Access Compliance Report Public Rights-of-Way (Curb Ramps)

Main Street: N_STALLION_ST Cross Street: E_ARABIAN_AVE Location: NE

ADA ID: RPRK211222115039 Ramp Type: Type 4 - Parallel Initial Pass/Fail: Fail Overall Compliance: No Severity Score: 15

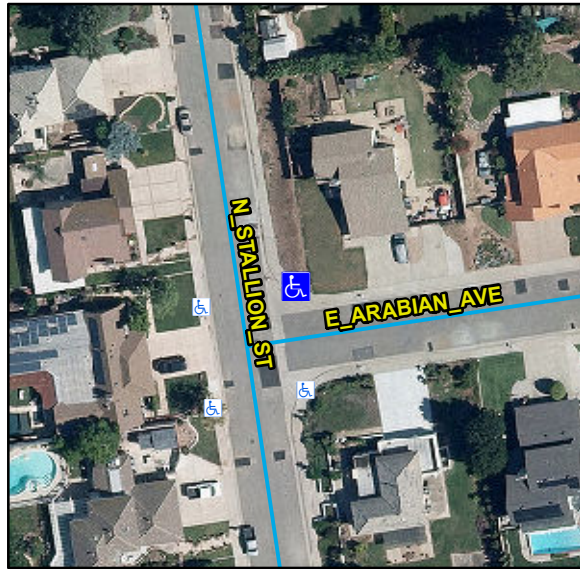
R304.3.2, R302.3, R402.2, STD 1115

Remove & Replace Curb Ramp With Two New Directional Ramps or Equivalent.
